APPLICATION FOR SUBMITTAL OF POST-APPROVAL DOCUMENT

2. PROJECT INFORMATION:			
School District/Owner: Lodi Unified School District		DSA File Number: 39 H4	
Project Name/School: Lodi High School Breezeway Repair		DSA Application Number 02 121377

CCD NO. 01 NARRATIVE

School District/Owner: **Lodi Unified School District**
Project Name/School: **Lodi High School**
DSA File/Appl No.: **39-H4 /02-121377**
CCD Number: **#01**

1" = 1'-0" 7 METAL STUD SOFFIT AT (E) WINDOW - PERPENDICULAR CONDITION

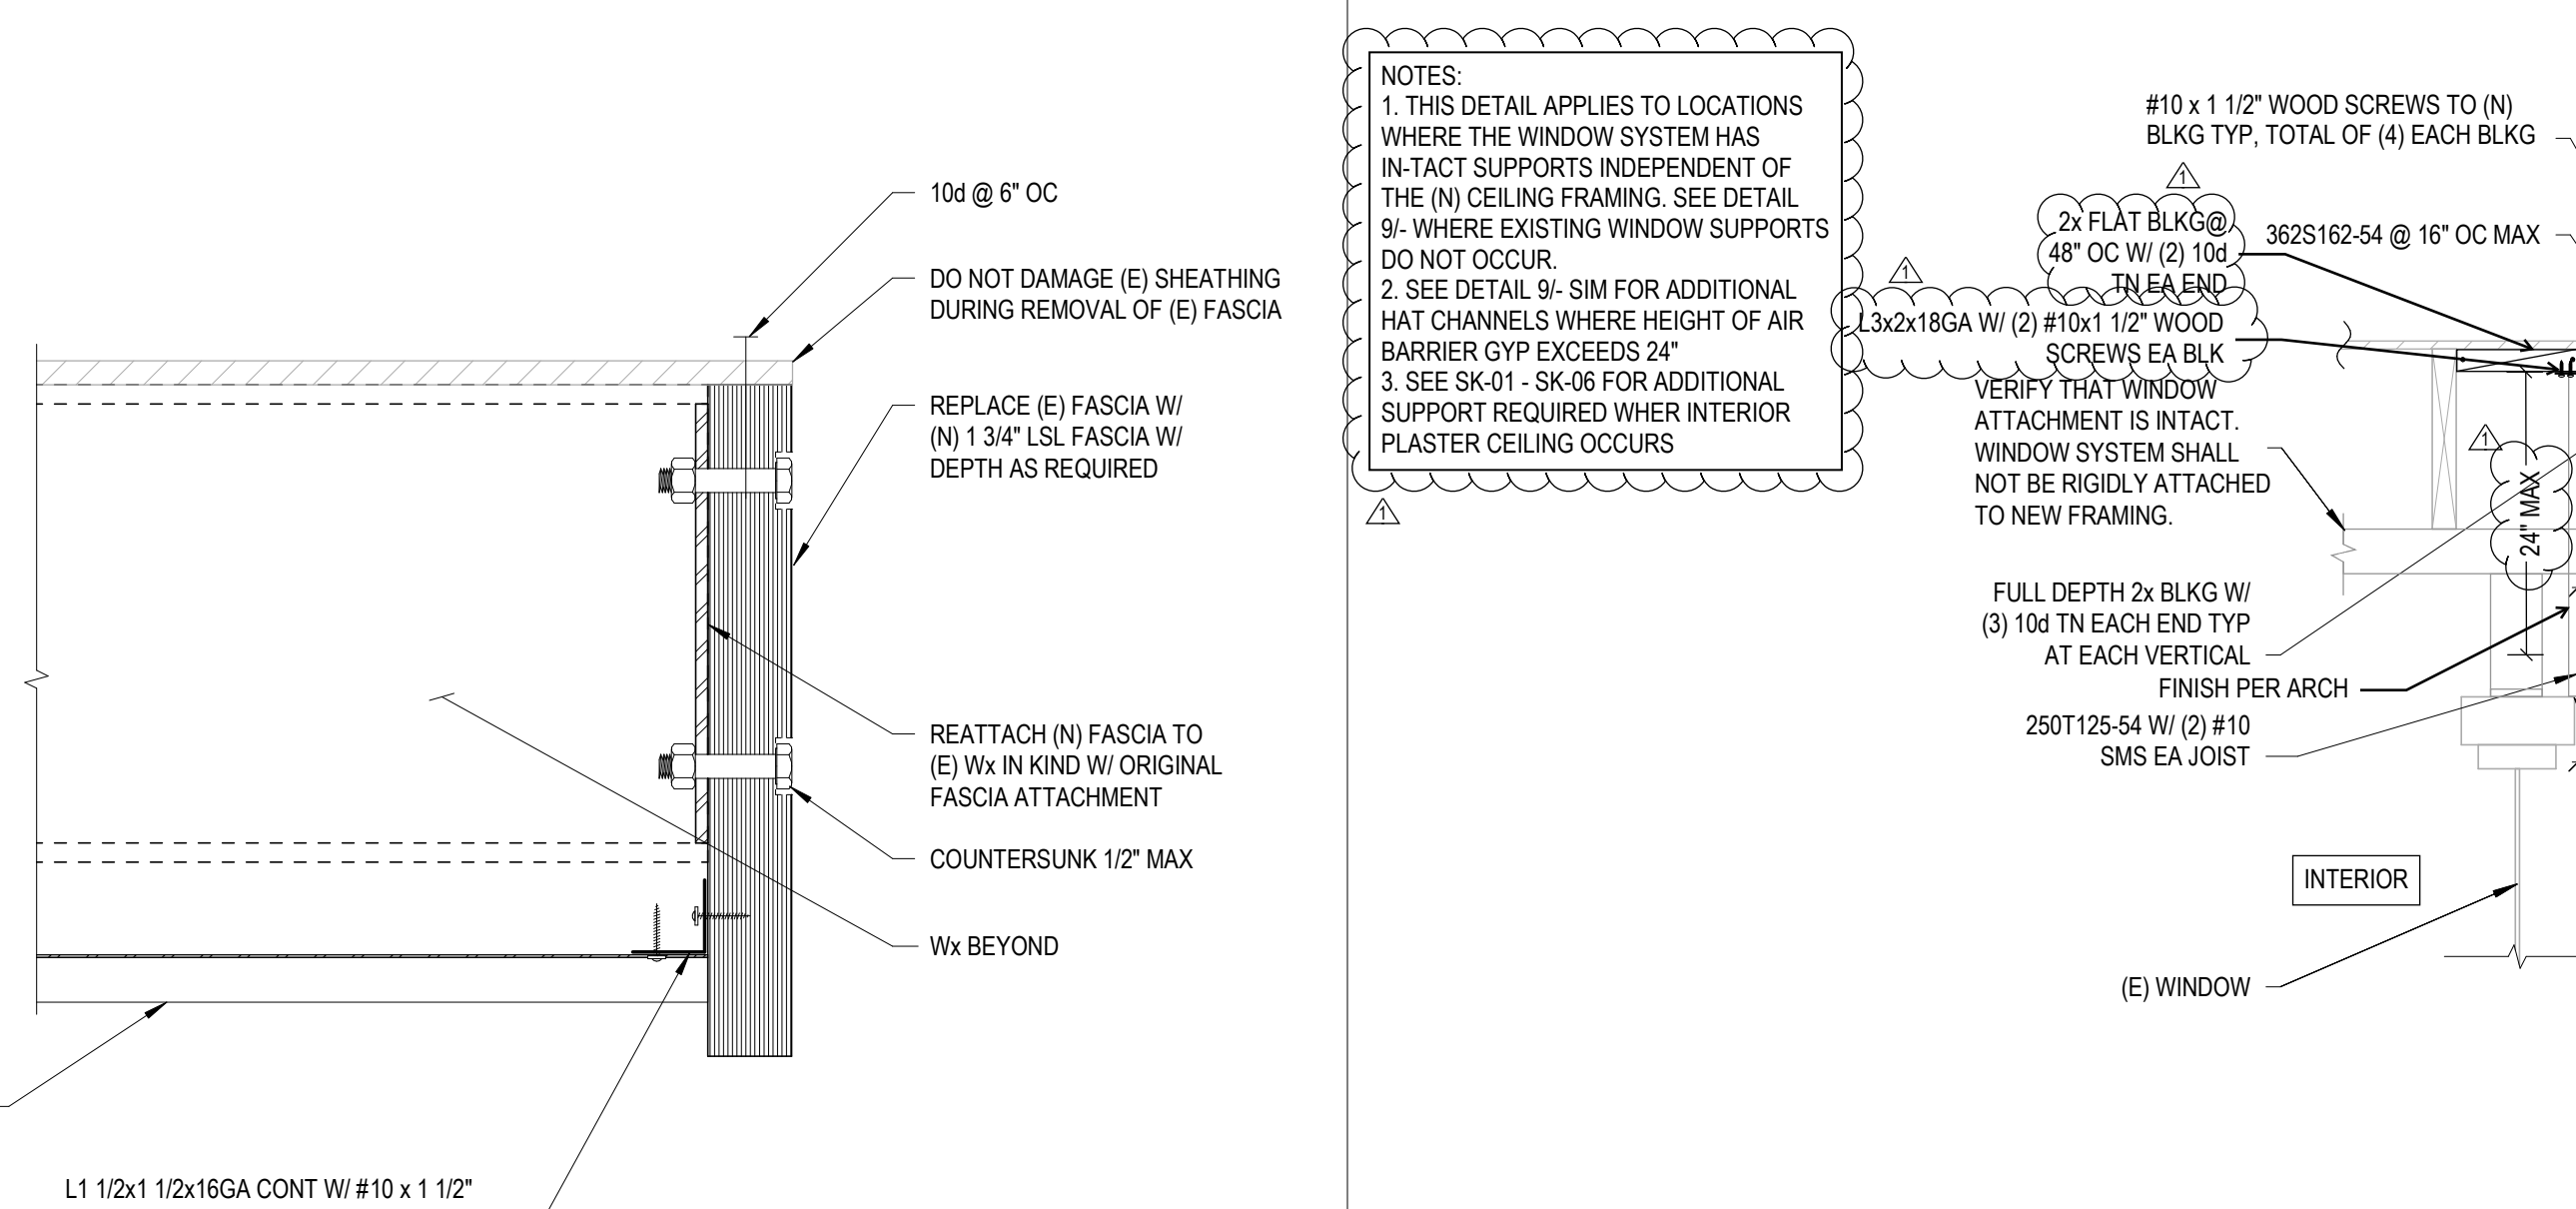
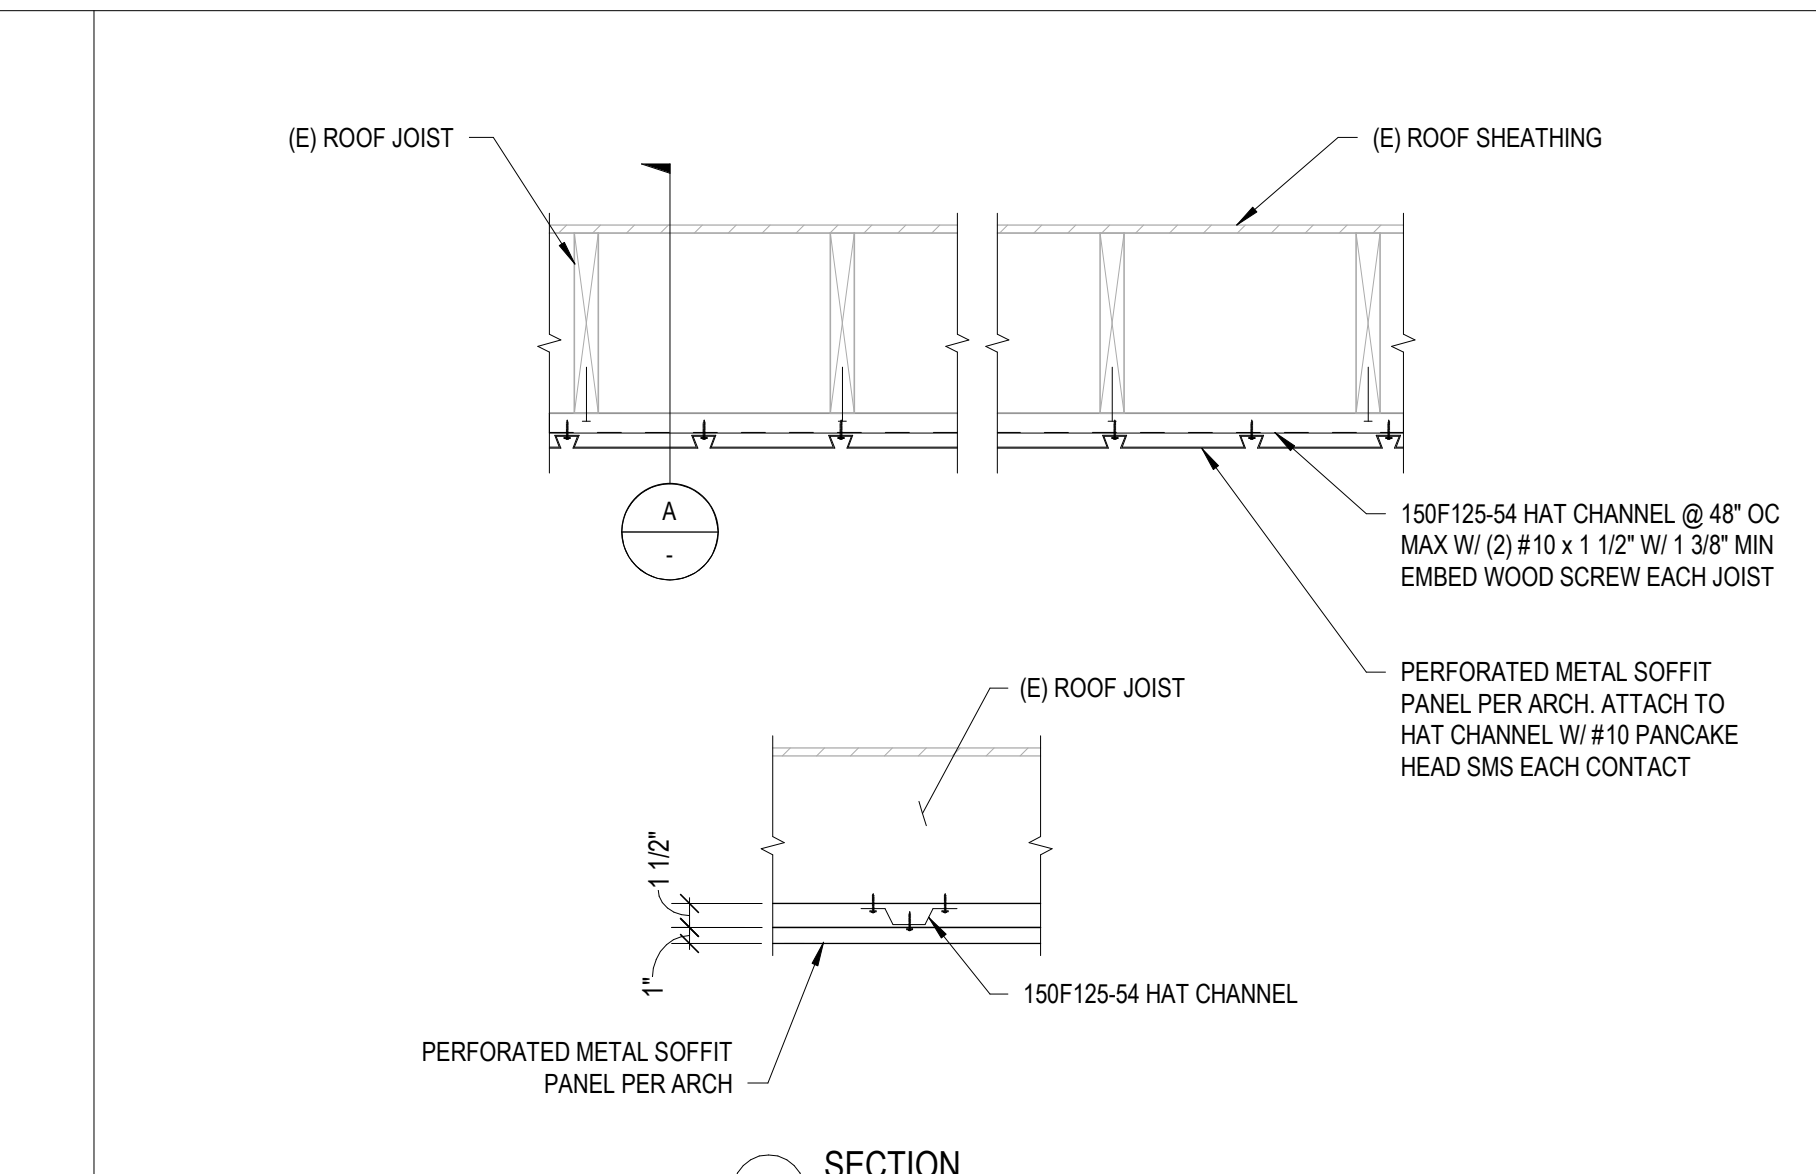
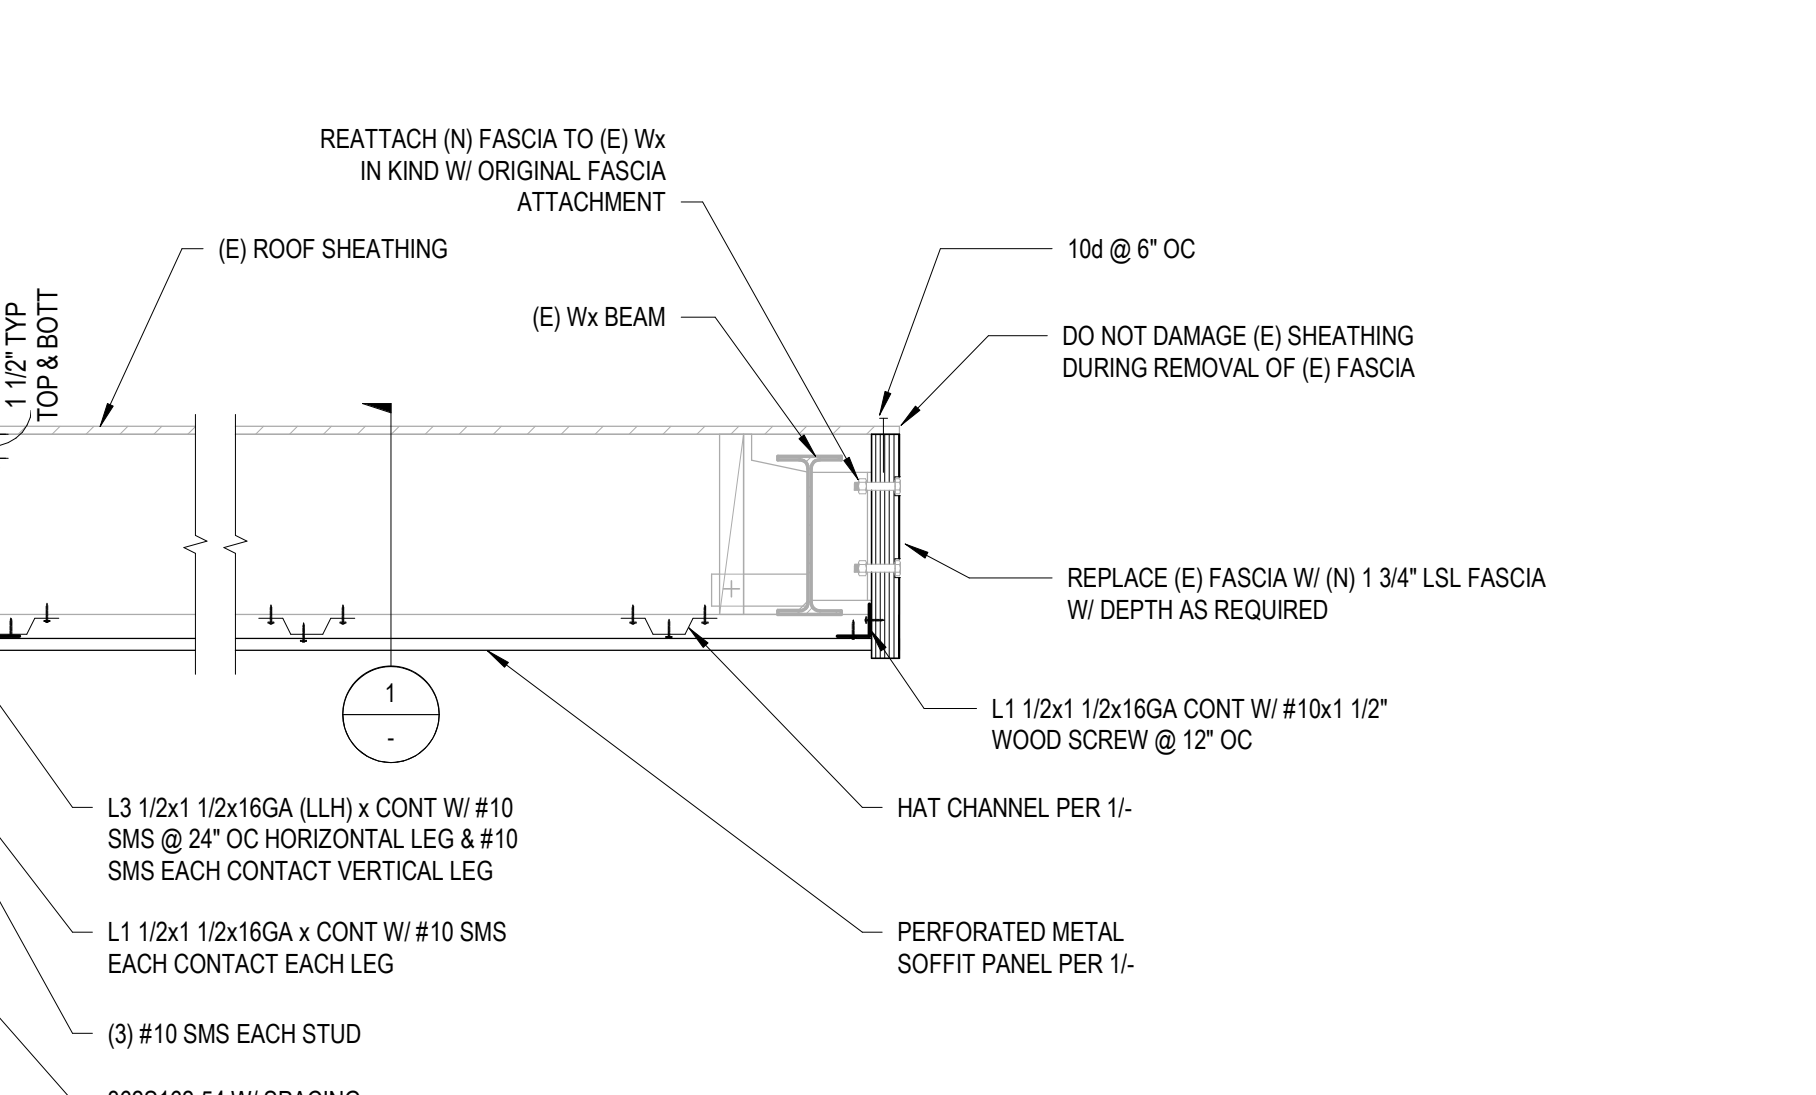
Details on sheet S2.1 have been revised to reflect new non-structural framing required to support an air barrier above windows. Additionally, sketches SK-01 – SK-06 have been included to show new support framing required for the currently unsupported section of plaster at the interior edge of the existing window systems.
